Plausibility of the Results from the Southeastern
Massachusetts Health Study

January 18, 1991

Epidemiology Resources Inc.

**Boston Edison Company
800 Boylston Street
Boston, MA 02199**

Figure 1
Observed and Expected Leukemias
in the MDPH Study Area, 1978-1983

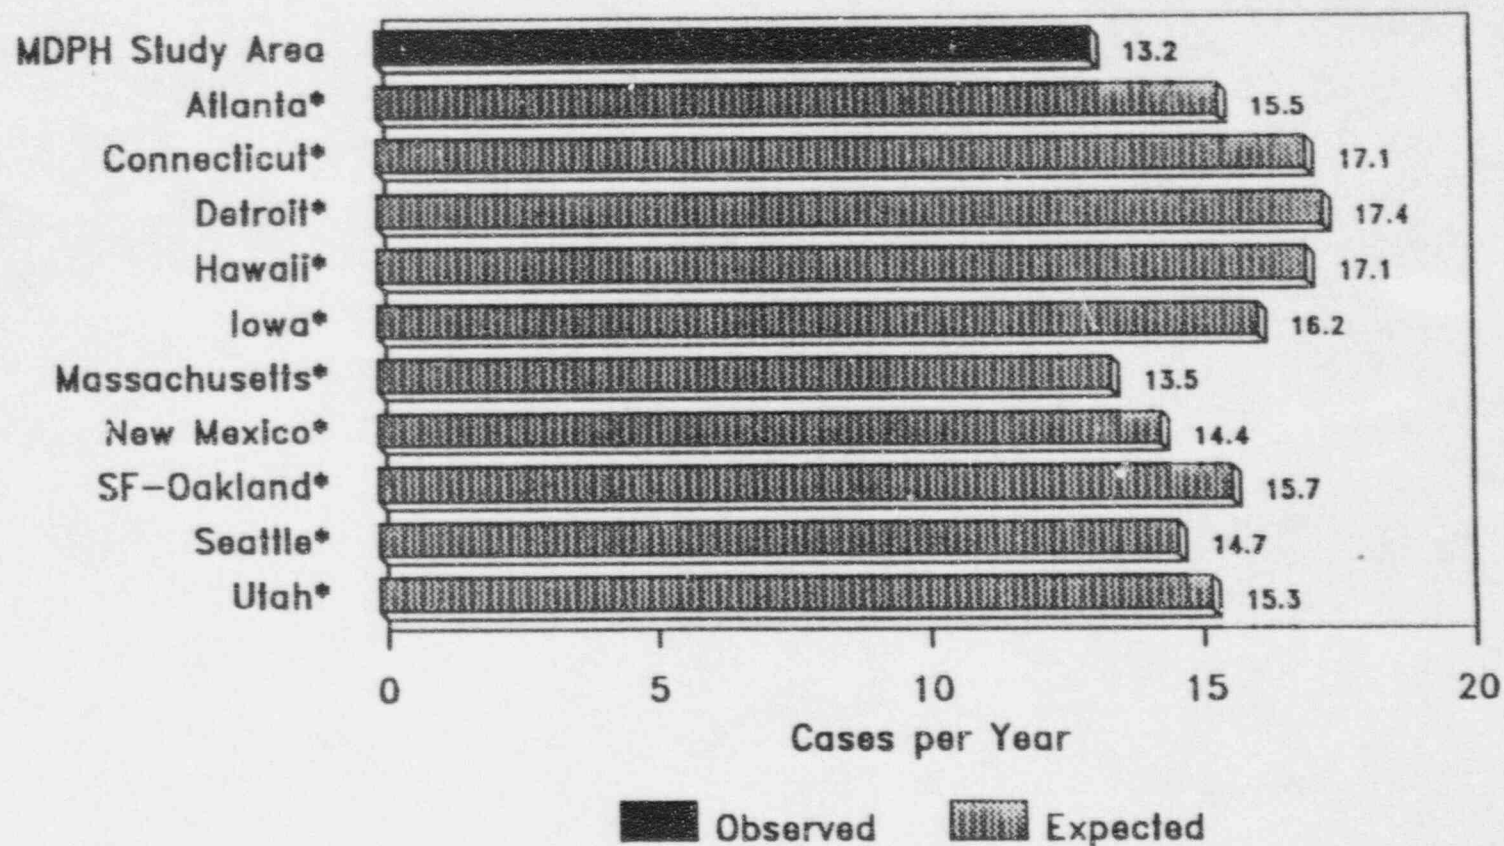
Figure 1 contrasts the observed number of 13.2 cases per year in the MDPH study area with the expected numbers based on the 10 comparison populations. Variability among the expected comparisons is minimal, with a range from 13.5 per year using Massachusetts rates to 17.4 per year using rates from the Detroit metropolitan area. The leukemia rate in the MDPH study area is virtually identical to the rate in Massachusetts as a whole and slightly lower than rates elsewhere in the United States. The threefold excess suggested by the MDPH study for the 22-town area is not remotely evident.

Figure 2
Leukemia by Time Since First Exposure
A-Bomb and MDPH Studies

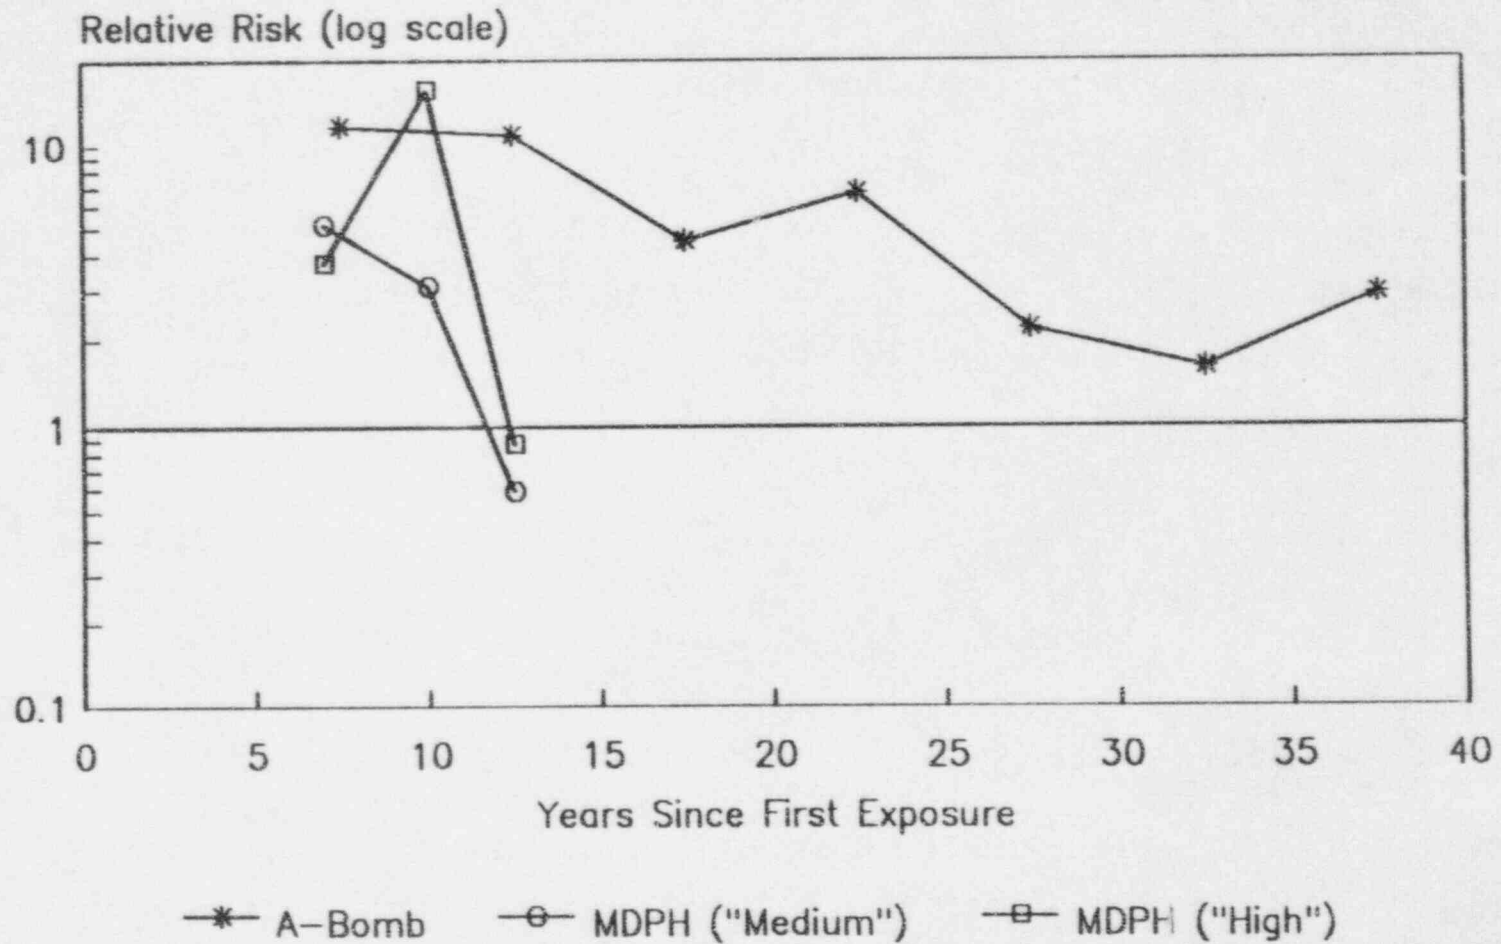
As shown in Figures 2 and 3, the disappearance of the association in the third time period is extremely inconsistent with the two key studies in the extensive existing literature on leukemia in relation to ionizing radiation: the ongoing studies of Japanese atomic bomb survivors (Figure 2, Shimizu et al. 1988) and of British ankylosing spondylitis patients treated with high doses of x-rays (Figure 3, Darby et al. 1987). In each of these studies, increased leukemia risk has been observed to persist for at least 30 years after initial exposure. (The relative risks in Figures 2 and 3 are plotted on logarithmic scales at the recommendation of Gladen and Rogan (1983) to account for the asymmetry of the relative-risk scale, on which inverse associations are represented by values of zero to one and direct associations by values of one to infinity. See also Morgenstern and Greenland (1990).)

The fact that the atomic bomb and ankylosing spondylitis studies measured leukemia mortality as opposed to leukemia incidence introduces a negligible bias into the contrasts in Figures 2 and 3 because, as previously noted, the average survival time for adult leukemia patients is less than one year (Axtell et al. 1976). The disappearance of the association in the MDPH study after a maximum of 11 years from Pilgrim plant start-up is another indication of the implausibility of the study's results.

Figure 4
Cumulative Radiation Dose from Pilgrim
Emissions, MDPH Study Area, 1972-1980

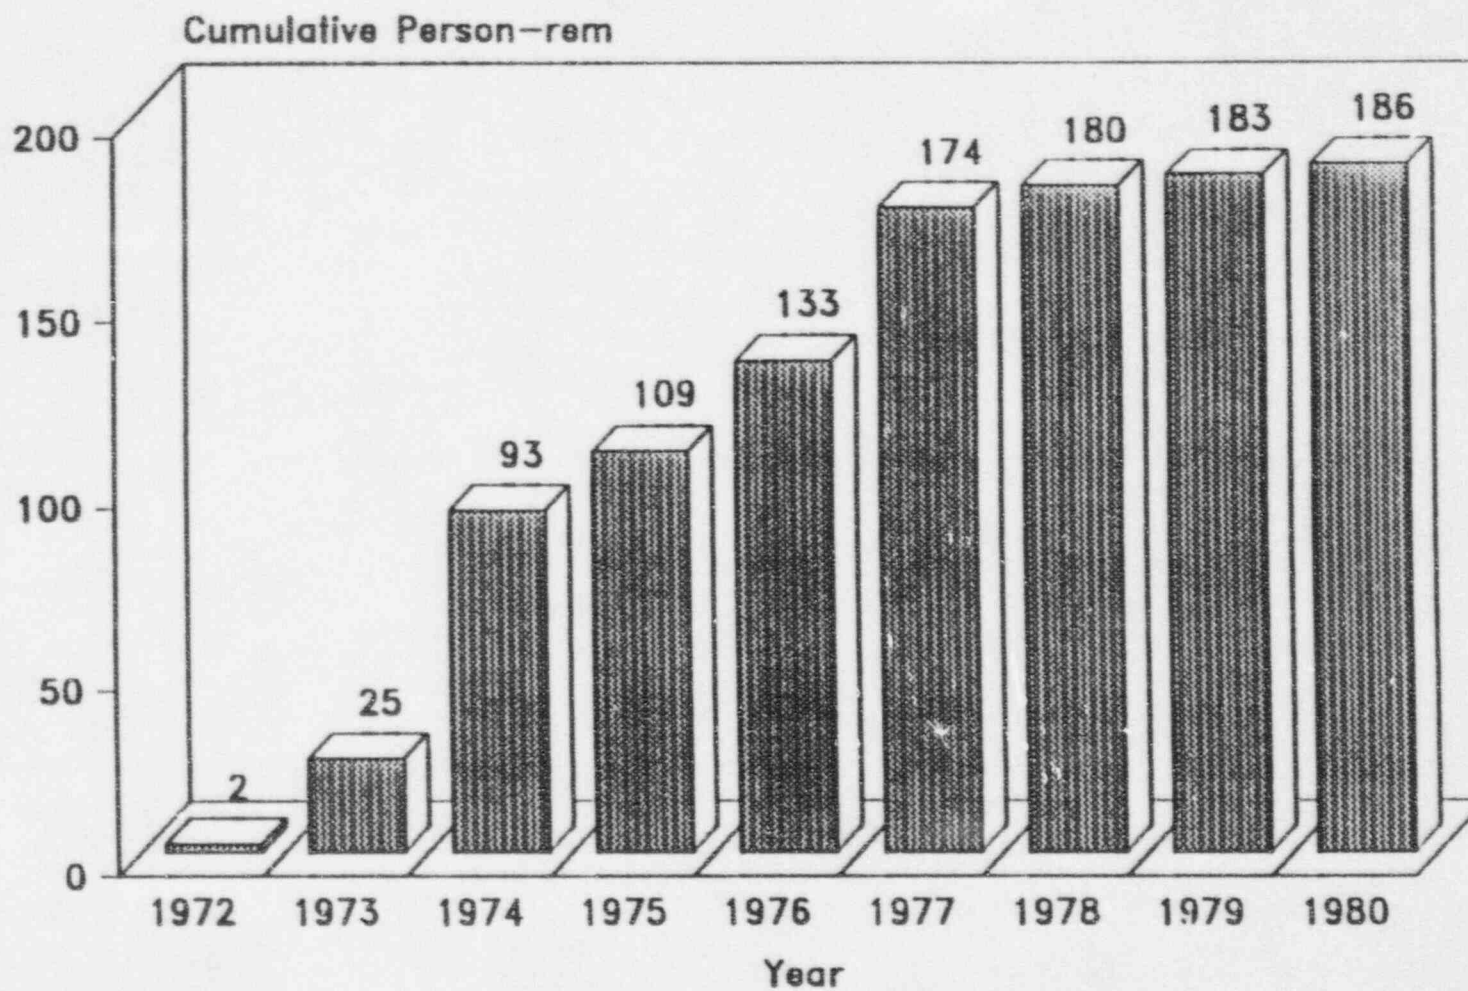
Cumulative population dose estimates, by year from 1972 to 1980, are shown in Figure 4 for the entire population residing within 20 miles of the Pilgrim plant. The estimates were produced by the Yankee Atomic Electric Company with standard dosimetry methods and using data that were collected and reported in each year of the study period. The dose estimates include not only the 22 towns in the MDPH study area, but also several towns on Cape Cod that lie within 20 miles of the plant but were not included in the study. Through 1978, the estimates indicate a population dose of 180 person-rem specifically from Pilgrim plant emissions. Because abnormal radiation releases in 1974 and 1977 dominate the cumulative dose through the present date, the results of the computations below would not be changed materially if

The starting point for the computation is the population dose that each of the three risk assessments predicts would be necessary to produce one leukemia. These doses, ranging from 6,500 to 13,900 person-rem (rounded to the nearest hundred person-rem), are shown in the first column of Table 4. The population doses required to produce the 54 ostensibly attributable leukemias estimated by the MDPH study (Table 1) are obtained simply by multiplying the figures in the first column of Table 4 by 54. By dividing the figures in the second column (which are rounded to the nearest thousand person-rem) by the 180 person-rem estimated for the 20-mile population (Figure 4), one can obtain "implausibility factors," or approximate indications of the degree to which the MDPH results are inconsistent with the three risk assessments. These factors (rounded to the nearest thousand) range from 2,000 to 4,000. Thus, the MDPH results differ by at least three orders of magnitude from the predictions of the three low-dose models.
